**RE: TRANSMITTAL - REPORT - TECHNICAL IMPRACTICABILITY OF GROUNDWATER  
RESTORATION EVALUATION  
WESTINGHOUSE ELECTRIC SHARON PLANT - SHARON, PENNSYLVANIA**

SUBJECT: Westinghouse Sharon Site  
**Technical Impracticability Of Ground Water  
Restoration Evaluation**

**RE: Westinghouse Sharon Site  
Ground Water TI Document**

**REPORT  
TECHNICAL IMPRACTICABILITY OF GROUNDWATER  
RESTORATION EVALUATION  
WESTINGHOUSE ELECTRIC (SHARON PLANT)  
SHARON, PENNSYLVANIA**

FIGURE 4-2  
APPROXIMATE LIMITS OF NON-  
AQUEOUS PHASE LIQUIDS—

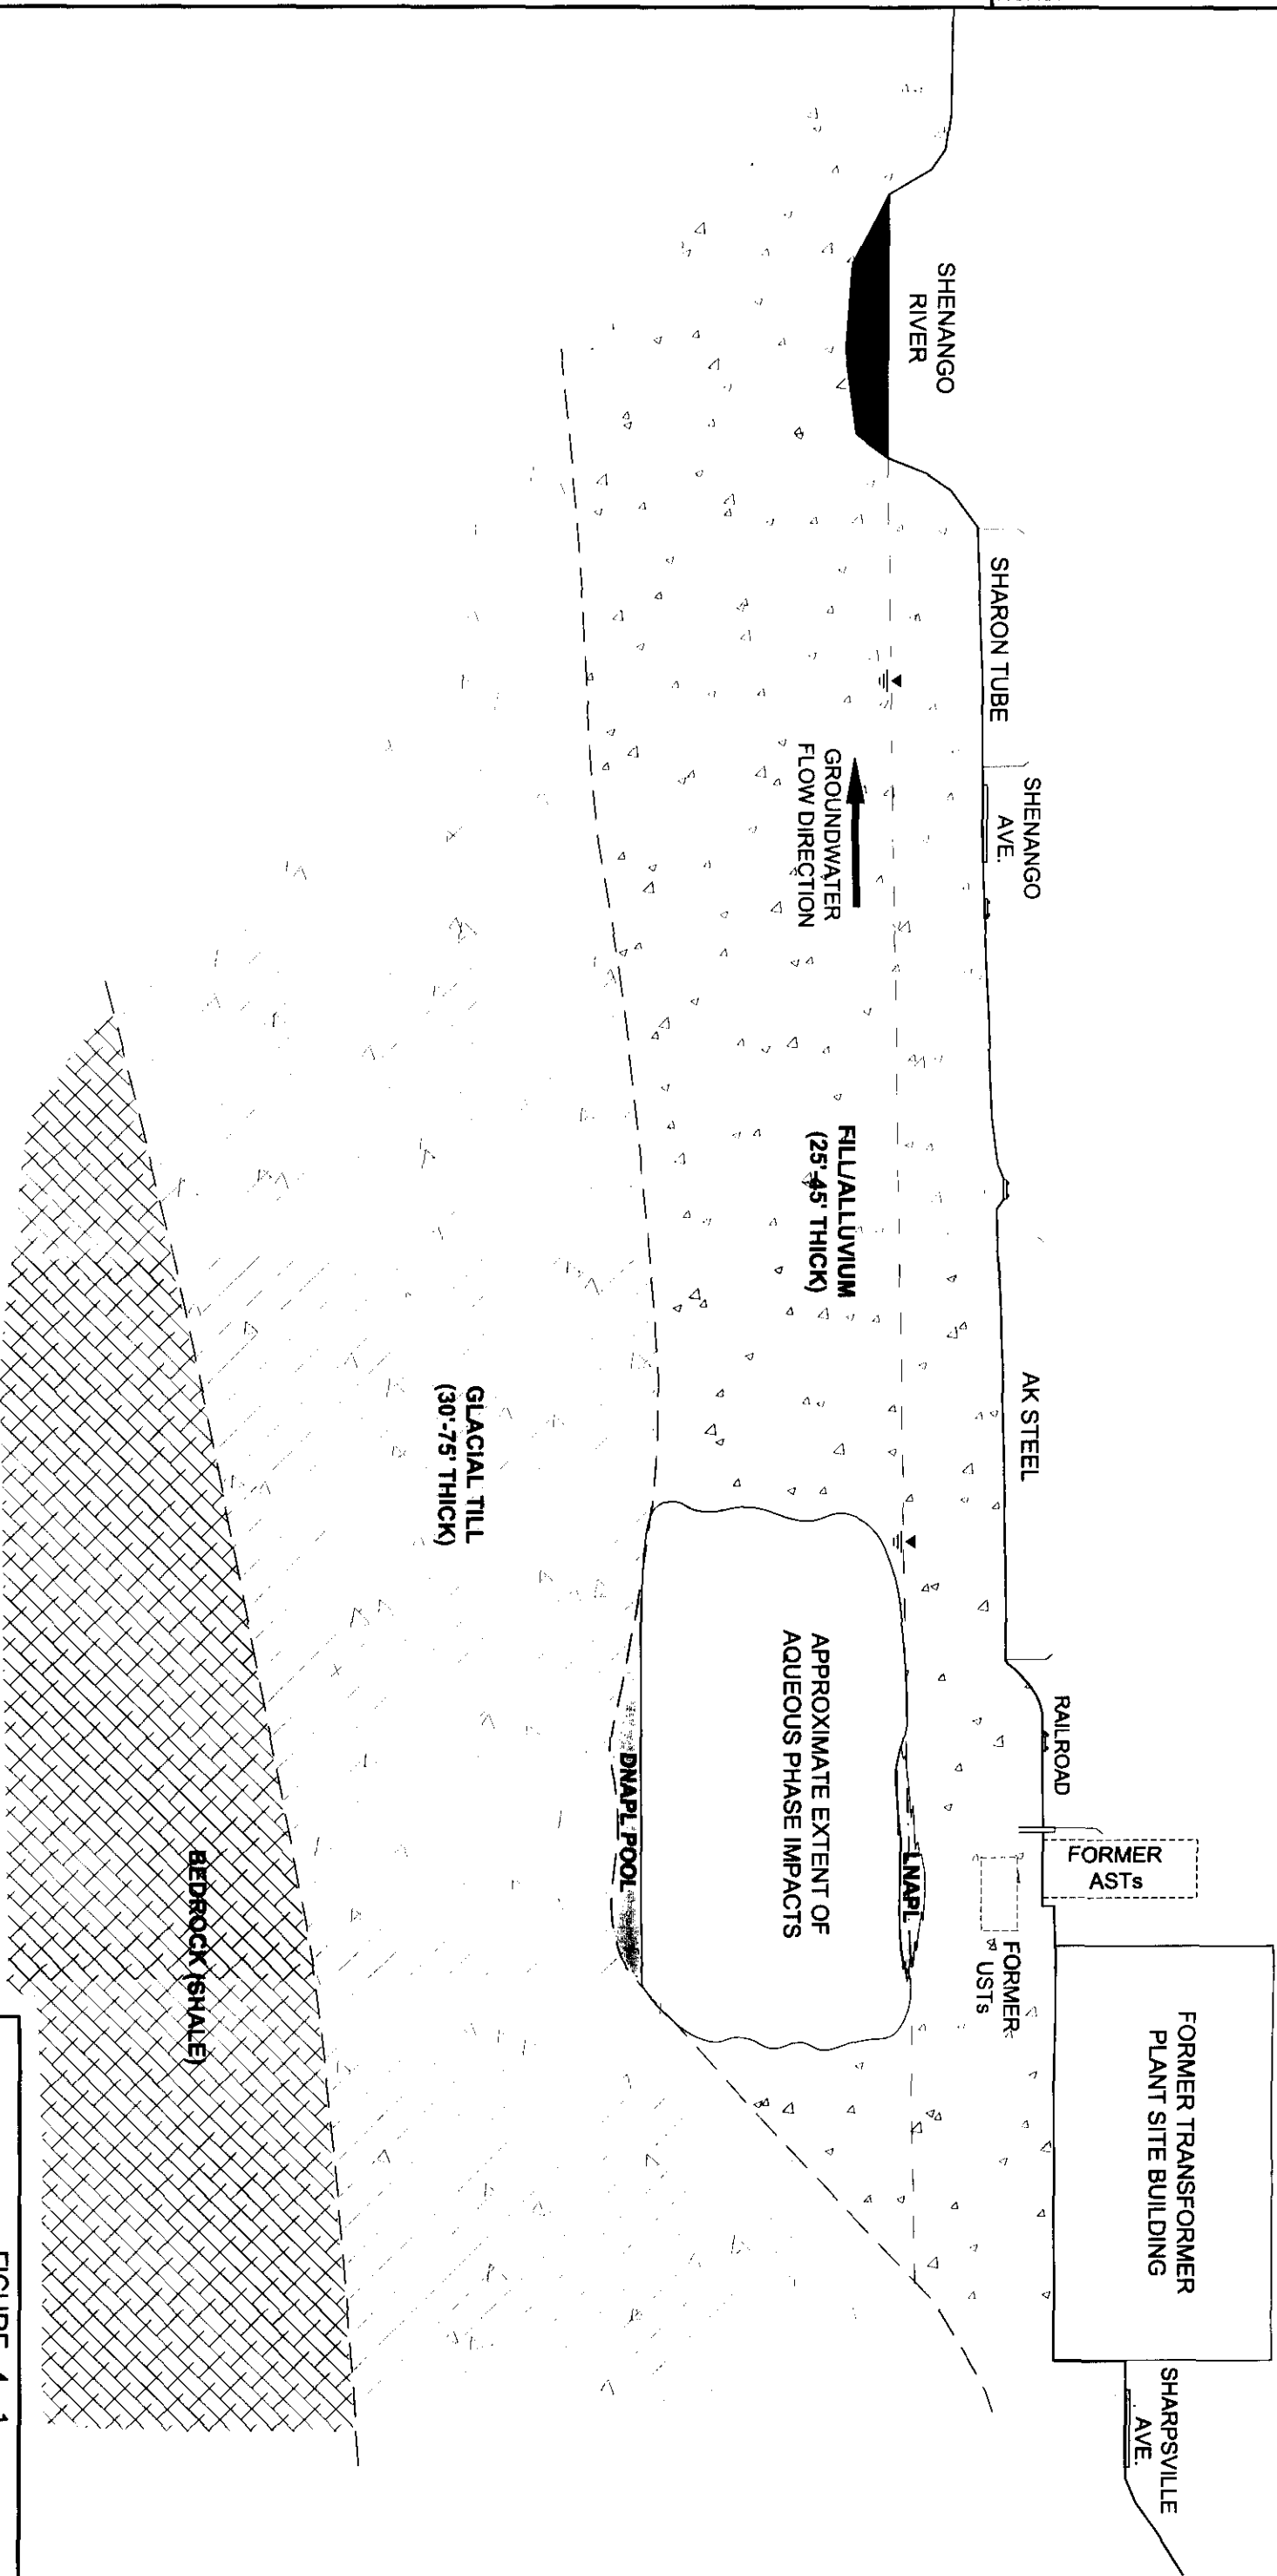
**COMMENT NO. 2 - Aqueous Plume: If it is technically infeasible to either cleanup or contain the NAPL pools, they would continuously feed the aqueous plume, making restoration of the aqueous plume impossible. Data provided in the TI Evaluation (Figures 5-14, 5-15, 5-16) indicate that the plume may not be stable. Therefore, MNA may not be able to contain the plume. The TI evaluation did not discuss containment of the aqueous plume; instead, it relied on MNA and an oversized TI Zone as the solution. Based on the data provided it appears that a more aggressive system should be evaluated to ensure protection against further down-gradient migration and river discharge. OERR recommends further delineation of the southern extent of this aqueous plume and evaluation of possible containment measures.**

Zone area is shown on revised Figure 4-2 (attached). The proposed TI Zone area occupies approximately 35 percent of the groundwater use restriction area. Based on the available sampling and analysis data, and our current understanding of contaminant fate and transport properties, groundwater impacts resulting from historical activities at the Westinghouse Sharon Site do not exceed the boundary of the proposed TI Zone.

**RESPONSE:** Based upon discussions with USEPA, Region 3 representatives, the proposed TI Zone has been modified and is shown on revised Figure 4-2. The revised TI Zone utilizes readily discernable surface features to designate its boundaries while minimizing its extent. As noted in the response to OERR Comment No. 1, and as discussed in Section 5.5.4, it is recognized that additional monitoring wells will be required along the boundary of the proposed TI Zone to monitor for site-related contaminants.
